ARTICLE 14. ONE AND TWO FAMILY DWELLING CODE

Rule 2.1. CABO One and Two Family Dwelling Code; Amendments

FIGURE R502.8
CUTTING, NOTCHING AND DRILLING

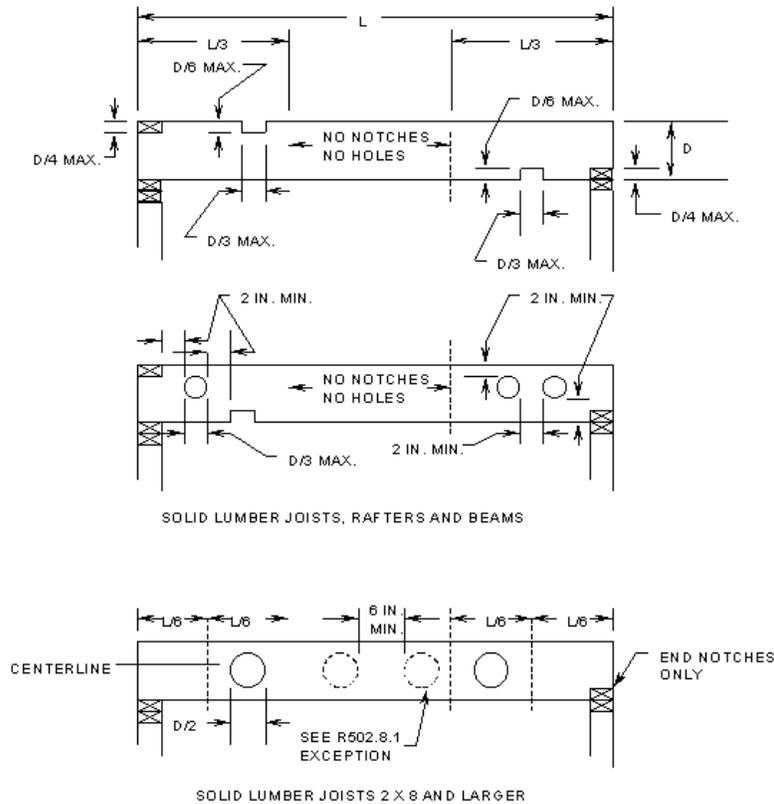
Sec. 88. Delete FIGURE R502.8 and substitute as follows: FIGURE R502.8:

FIGURE R602.6(2)
NOTCHING AND BORED HOLE LIMITATIONS FOR INTERIOR NONBEARING WALLS

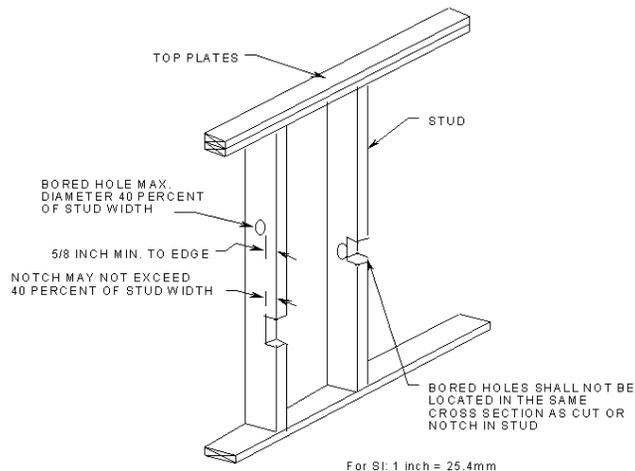
Sec. 95. Delete FIGURE R602.6(2) and insert FIGURE R602.6(2) to read as follows:

FIGURE R602.10.5(2)
GARAGE DOOR BRACED WALL PANEL FOR USE WITH CONTINUOUSLY SHEATHED WALLS

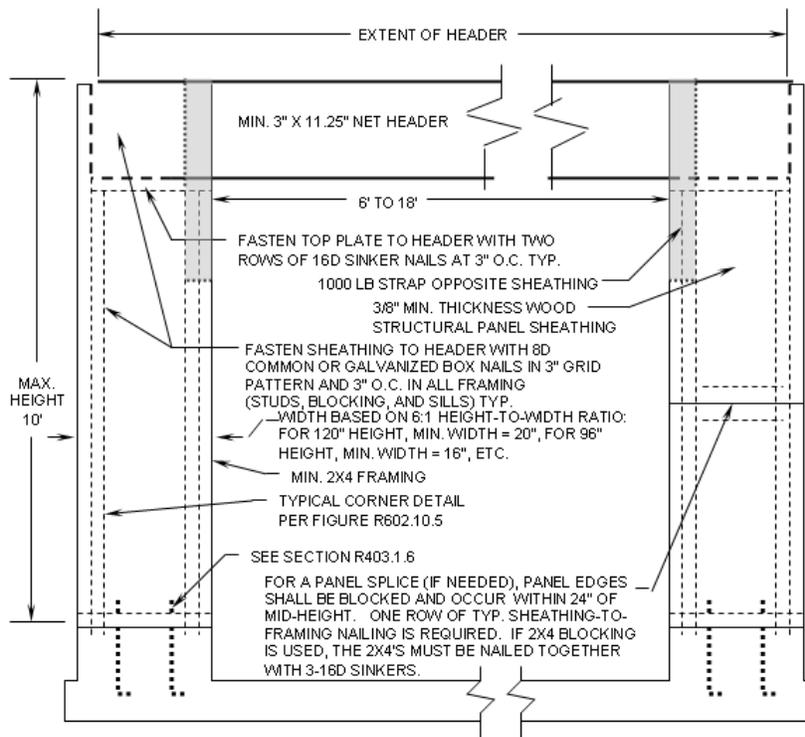
(3) Add an exception to read as follows: Exception: Vertical wall segments in the first of one or first of two story buildings next to garage openings shall be permitted to have 6:1 height-to-width ratio (with height being measured from top of header to sill plate) when constructed in accordance with the following provisions. Each panel shall have a length of not less than 16 inches (406 mm) and a height of not more than 10 feet (3,048 mm). Each panel shall be sheathed on one face with a single layer of 3/8 inch minimum thickness (9.5 mm) wood structural panel sheathing nailed with 8d common or galvanized box nails in accordance with Figure R602.10.5(2). The wood structural panel sheathing shall extend up over the solid sawn or glued-laminated header and shall be nailed in accordance with Figure R602.10.5(2). The header shall extend between the inside faces of the first full-length outer studs of each panel. The clear span of the header between the inner studs of each panel shall be not less than 6 feet (1,829 mm) and not more than 18 feet (5,486 mm) in length. A strap with an uplift capacity of not less than 1,000 pounds (454 kg) shall fasten the header to the side of the inner studs opposite the sheathing. Two anchor bolts shall be installed in accordance with Section R403.1.6, and plate washers shall be a minimum of 2 inches by 2 inches by 3/16 inch (51 mm by 51 mm by 4.8 mm) thick and shall be used on each bolt. This exception is only permitted in Seismic Design Categories A-C.

(4) Add FIGURE R602.10.5(2) to read as follows:

FIGURE R703.7.6(1)

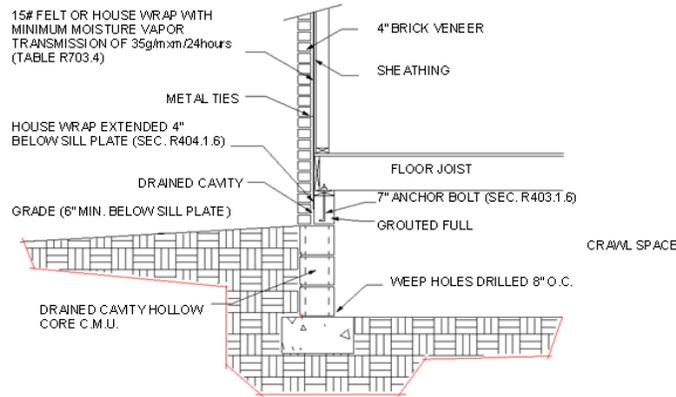
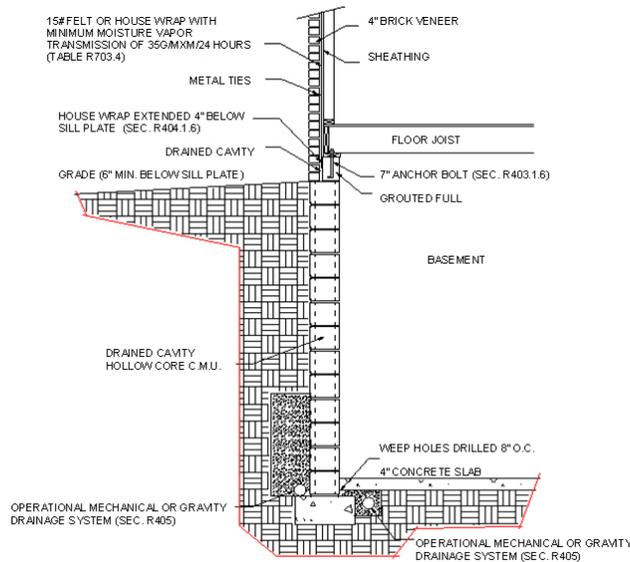
mm) air cavity shall be drained to the exterior of the structure at intervals of not more than 33 inches (838 mm) on center. Each drain shall be not less than $\frac{3}{16}$ inch (4.8 mm) in diameter, located immediately above the flashing. For dwellings with crawl spaces, the air cavity may be drained as shown in FIGURE R703.7.6(1). For dwellings with basements, the air cavity may be drained as shown in FIGURE R703.7.6(2).

FIGURE R1001.6
Chimney Termination

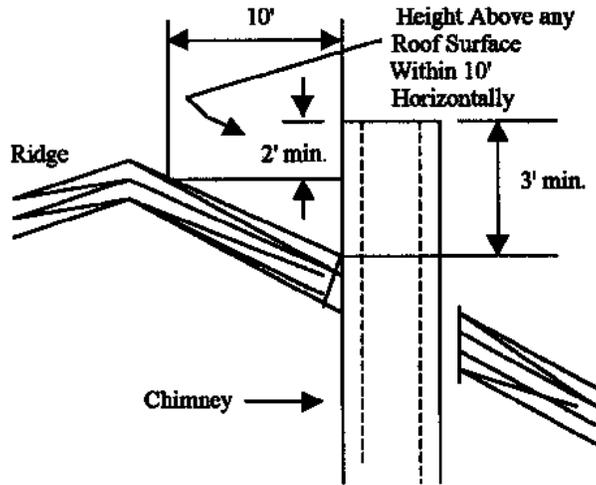
Sec. 135. Add FIGURE R1001.6 as follows:

FIGURE E3801.4.1

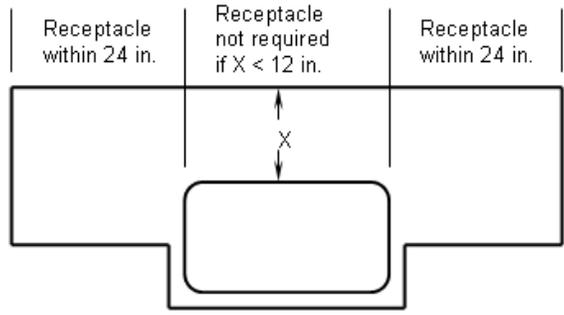
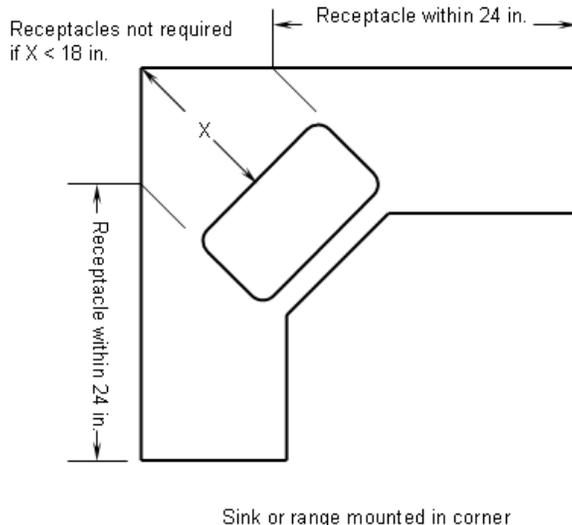
Sec. 229.5. (a) After SECTION E3801.4.1, add an exception to read as follows: Exception: Receptacle outlets shall not be required on a wall directly behind a range or sink in the installation described in FIGURE E3801.4.1.

(b) After SECTION E3801.4.1, add FIGURE E3801.4.1 as follows:
